**Flood Control Project Maintenance
Levee Inspections**

Maintenance Issue Types Only, Levee Inspection Report By Mile - Spring 2018

Reclamation District No. 2058 Pescadero

Waterway	Bank	Unit Miles	Inspection Start/End	Inspector
Unit No. 01 Paradise Cut	Left	6.58	03/12/2018 03/12/2018	Maksim Khashchuk

Photo 3 of 5 : SP_2018_RD2058_111_40_20180305_00032.jpg

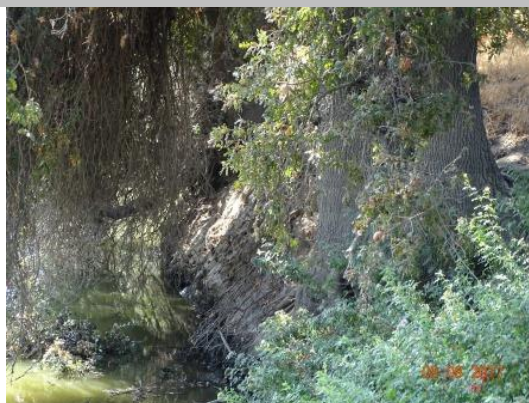
LM Start	4.63	Rating **	A/W	Issue No.	40 (cont)	
LM End	4.76	Issue Type +	Ma	Location *	WS	
Category	Earthen Levee			GPS Latitude/Longitude		
				Start	End	
Item	Erosion / Bank Caving			37.787756 °	37.785971 °	
				-121.350851 °	-121.350372 °	
DWR ID	DWR_RD2058_01_f_2017_40					
Comment Code						
E2 : Schedule repair of erosion site prior to the next inspection.						
Inspector Comment						
Erosion on the waterside is greater than three feet tall into the levee prism.

Upstream view of the erosion site.
